Before the Board of Inquiry
Waterview Connection Project

in the matter of: a Board of Inquiry appointed under s 149J of the Resource Management Act 1991 to decide notices of requirement and resource consent applications by the NZ Transport Agency for the Waterview Connection Project

Rebuttal evidence of **Lynne Hancock (urban design)** on behalf of the **NZ Transport Agency**

Dated: 2 February 2011

Title: URBAN DESIGN AND
LANDSCAPE PLANS
SHEET 217

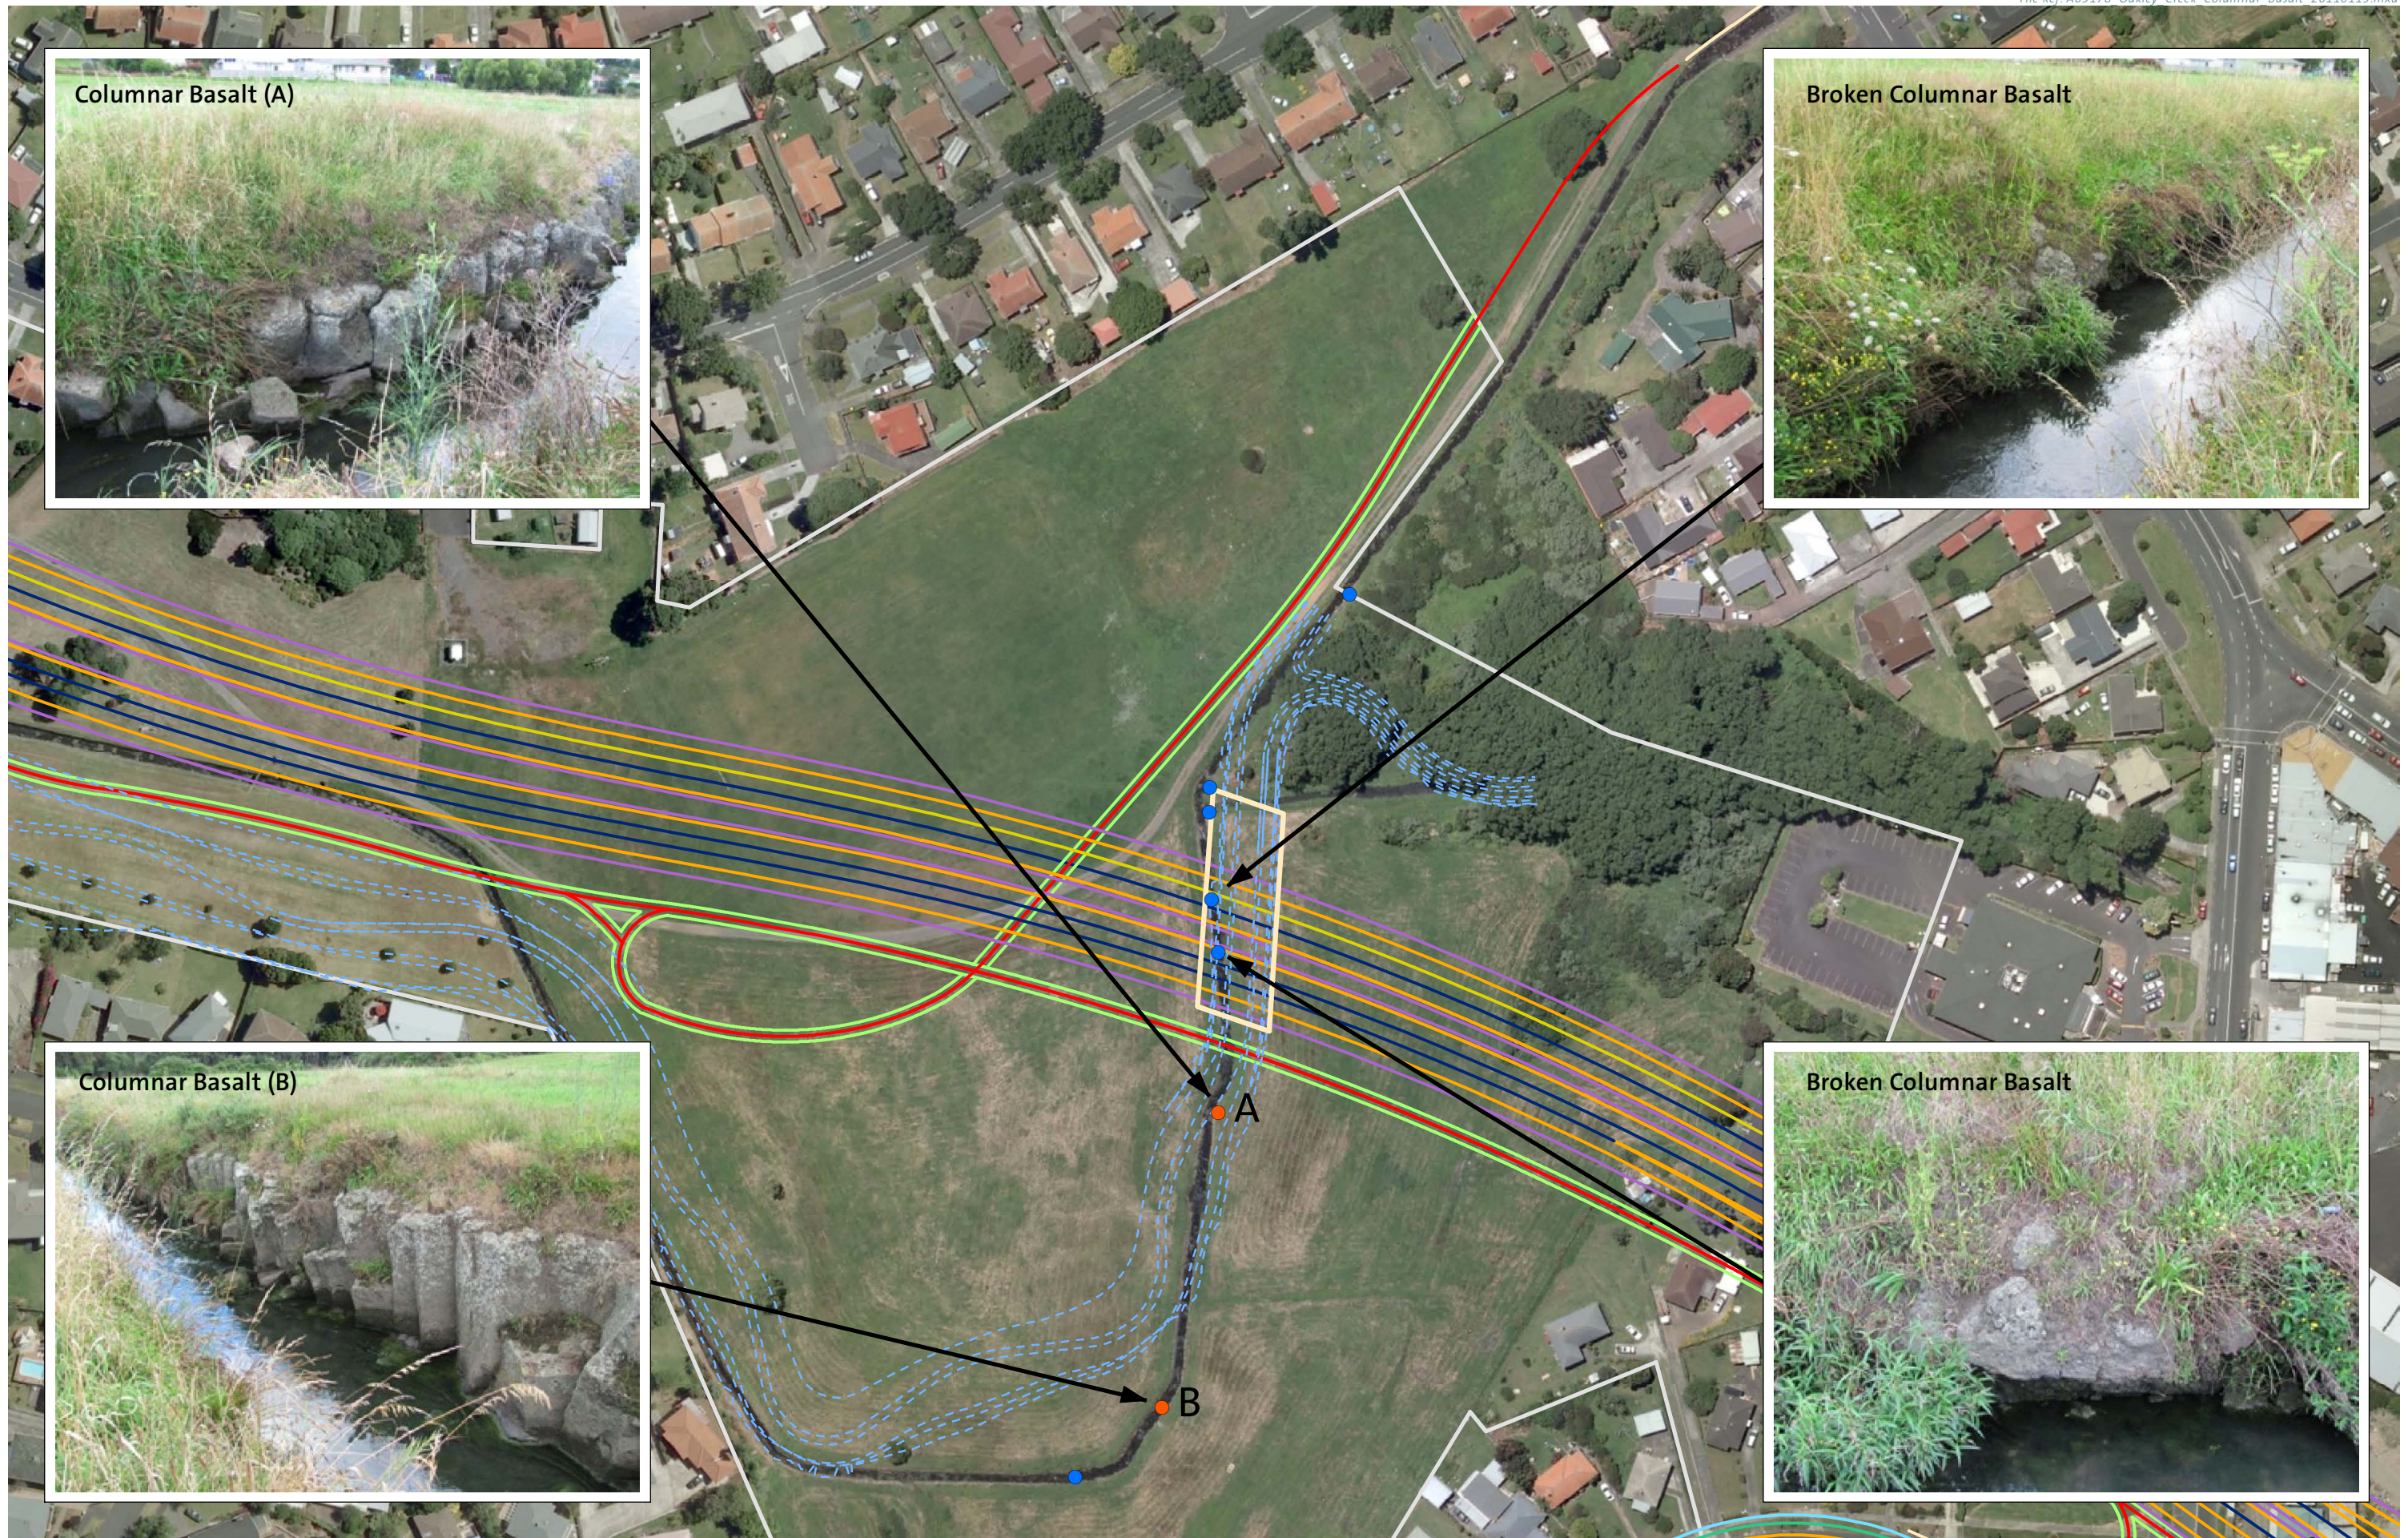
- 7 Mr Scott and Ms Absolum propose additional large scale planting around the north vent buildings.² While I am in support of providing as much planting as possible on the area remaining, I note the obvious constraint here is the extent of underground structures, which reduce the available soil depth for planting. This was discussed in the landscape and visual caucus where it was agreed that it is desirable to achieve as many large scale specimen trees as possible around the portal buildings to provide a backdrop and moderate the apparent scale of the vent stack. Revised Plan Number F16:217 therefore shows the additional planting proposed with the Construct design concept for the northern vent buildings.³

- 8 Mr Scott also recommends extending the urban forest concept as far as Oakley Avenue.⁴ I do not support that proposal. It would undermine the potential to return nos. 1445 – 1449 Great North Road to residential use post-construction, which is a positive outcome of the reduced footprint resulting from the revised design concept. In my opinion, reintroduction of active uses on that land would frame and strengthen the corner, tie back into the Oakley Avenue built character, and somewhat reduce the 'urban gap'.

³ This revised plan is contained in **Annexure A** to my rebuttal evidence. (UDL Plan sheet F16:217, Rev C).

ANNEXURE A - REVISED PLAN NO. F16:217

No.	Revision	By	Chk	Appd	Date
C	REVISED FOR REBUTTAL EVIDENCE	DL/NR			31.01.11
B	ISSUE FOR STATUTORY APPROVAL	JJ			04.08.10
A	ISSUE FOR SRT/NZTA REVIEW	JJ			18.06.10

Indicative walk between Alford Street and Point Chevalier shops

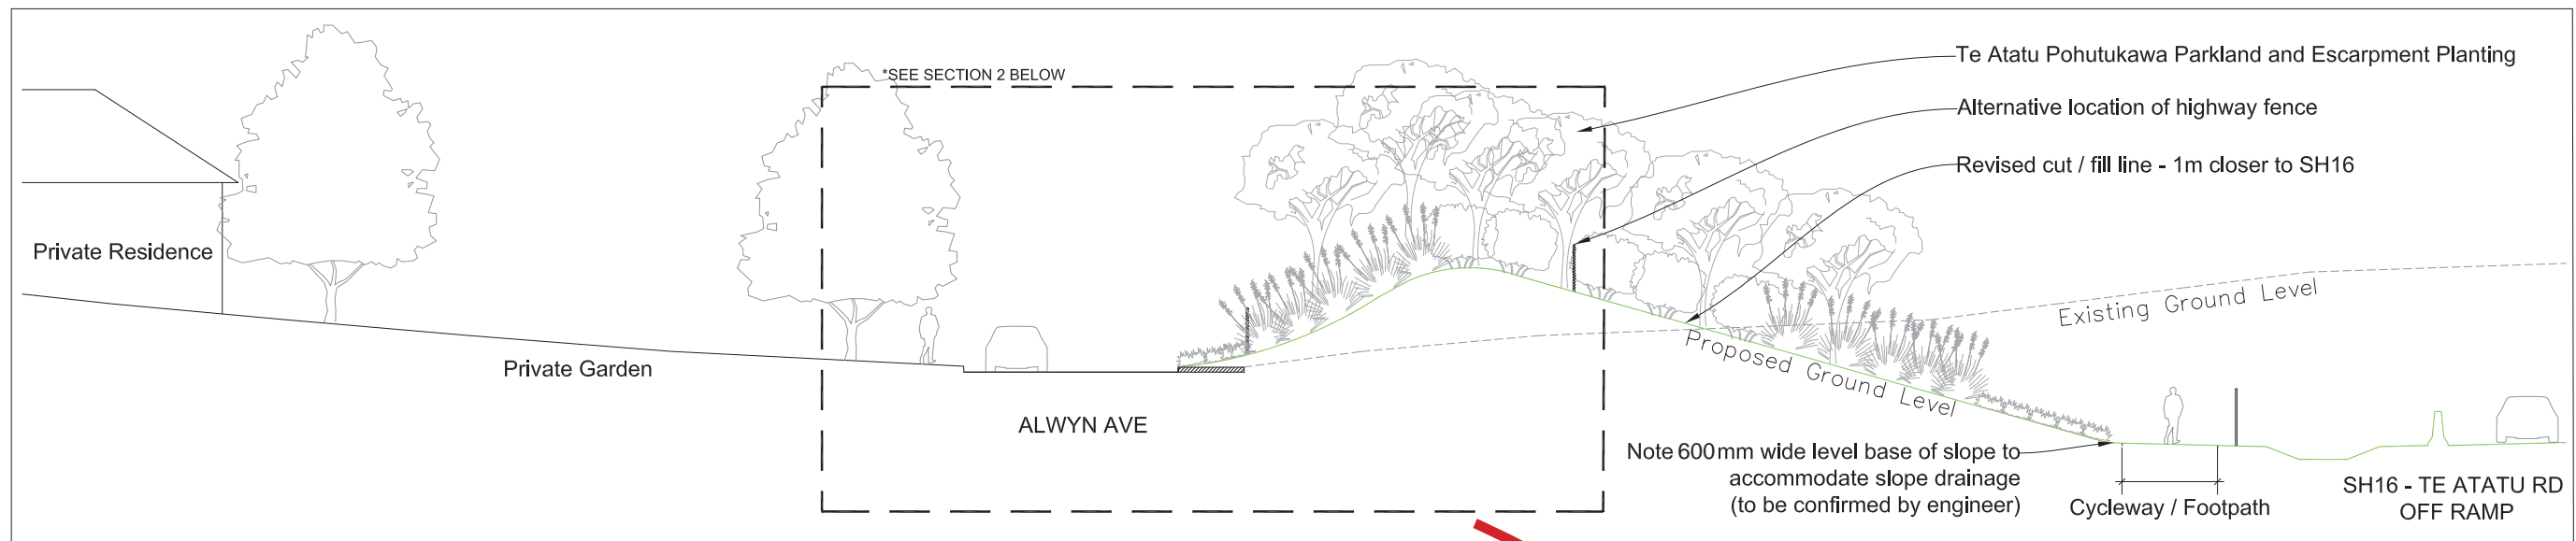
- 34 I also note that the walk through the Unitec grounds from roughly opposite Alford Street to the Point Chevalier shops is little more direct than using Great North Road itself (as shown in the attached

diagram);⁴⁷ and currently it is not well overlooked or connected into other uses. Therefore, while I acknowledge the submitters' desire for a bridge in this location, I see it as a longer term aspiration, ideally designed and delivered by stakeholders (including Auckland Council and Unitec) in an integrated way with Unitec's future campus planning.

**ANNEXURE F – CONCEPT SECTION FOR REVISED ALWYN AVENUE
BUND DESIGN**

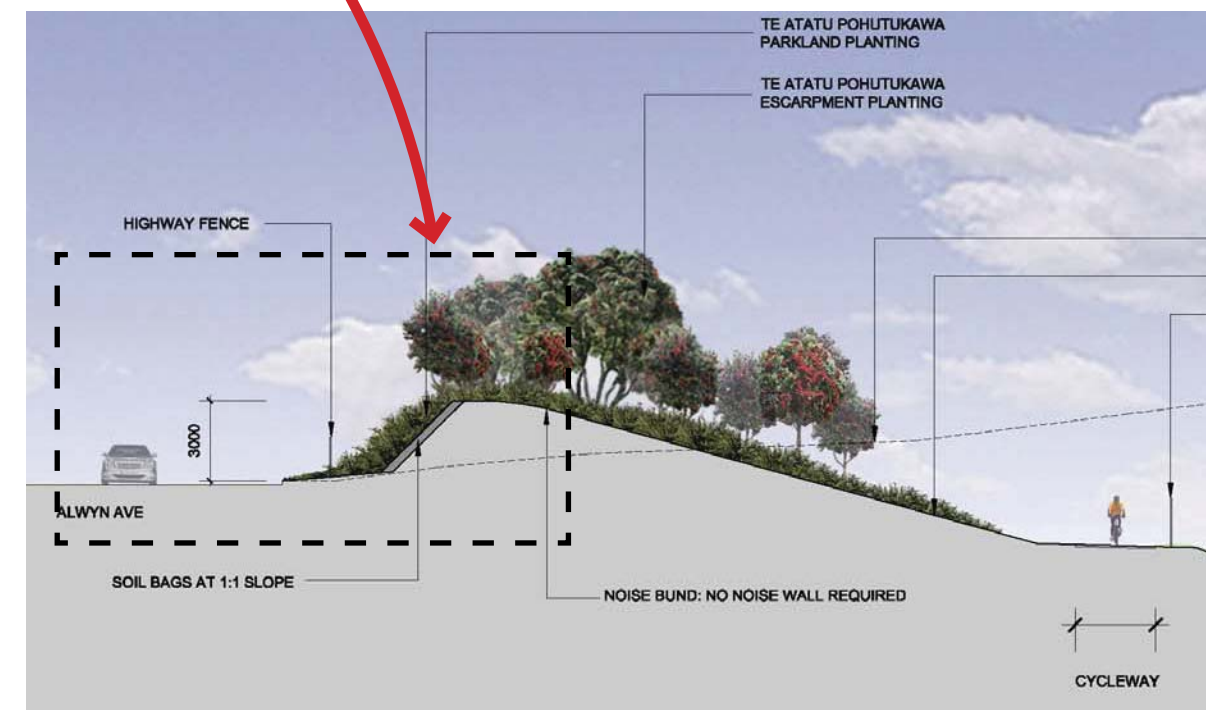
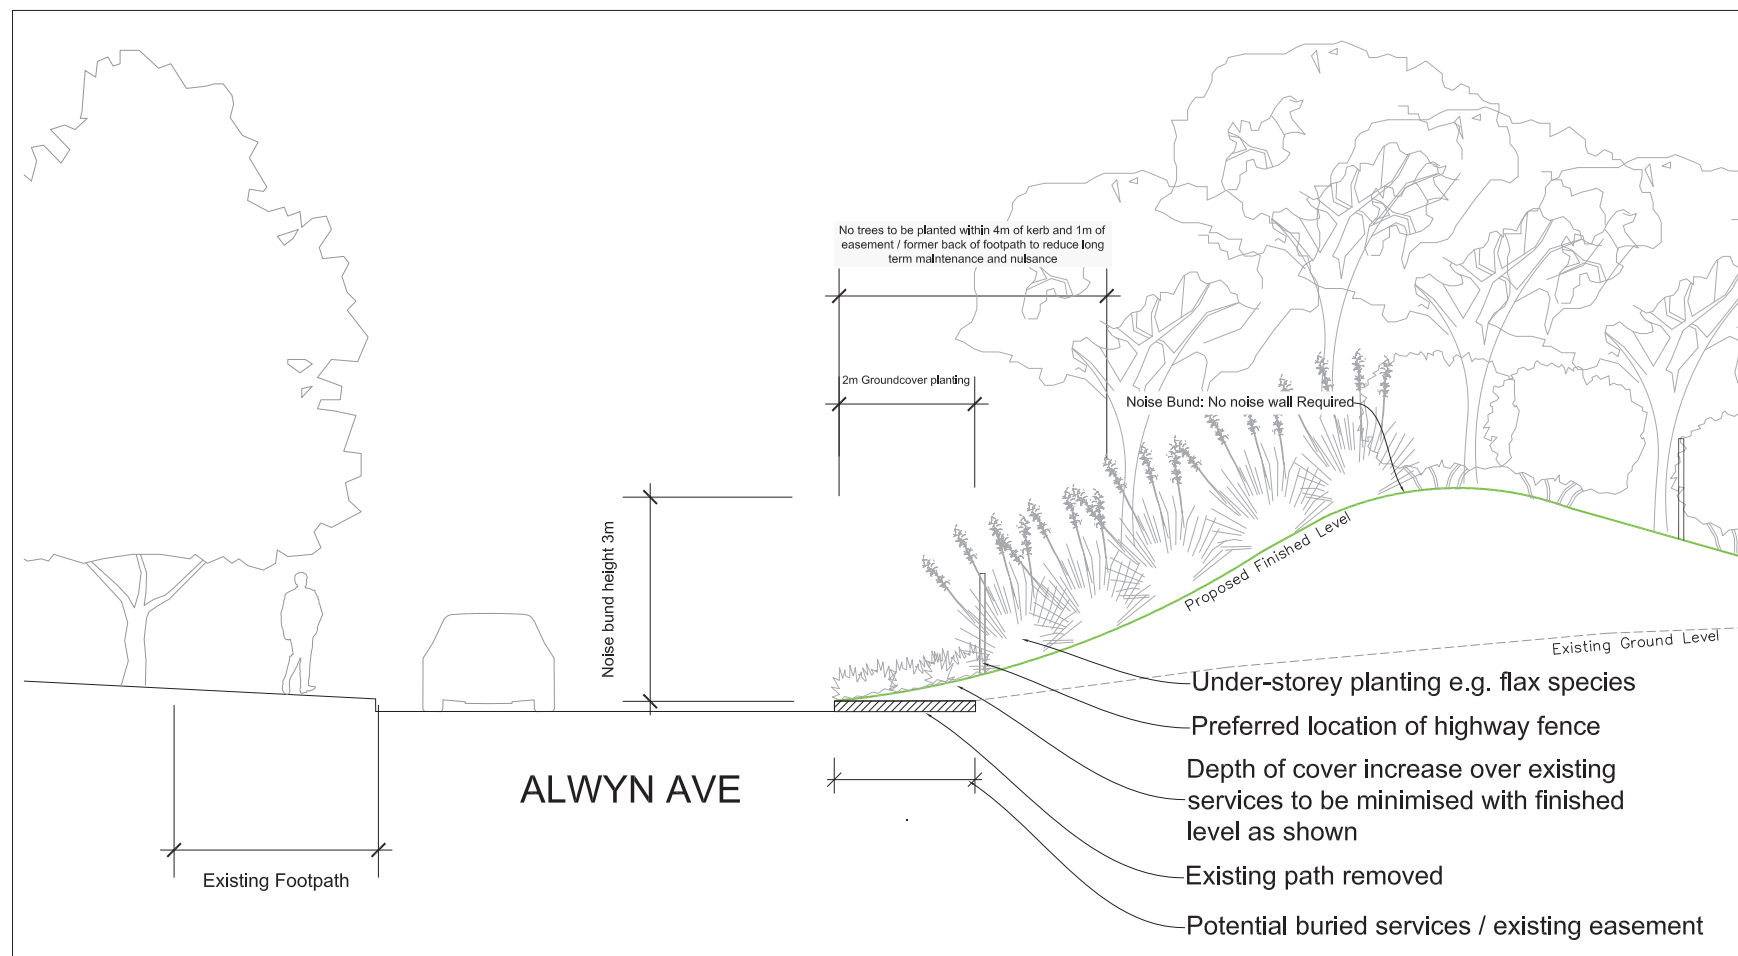
- 52 I understand from Mr Walter that the bund can be slightly reshaped or extended within acceptable engineering parameters and that there can be a slight refinement of the design to create a 'softer' profile to Alwyn Street and allow for more varied planting of shrubs than the current 1:1 slope would support. I attach an indicative concept section showing how this might be achieved.⁶⁴

- 53 I note however that there is no inconsistency between this indicative section and the UDL Plan No. F16:203 as lodged, and that no adjustment to that Plan is required. Rather this will be a matter for detail design.

⁶⁴ See **Annexure F** Concept section for revised Alwyn Avenue noise bund design and comparison with the current section (from the Urban and Landscape Design Framework).
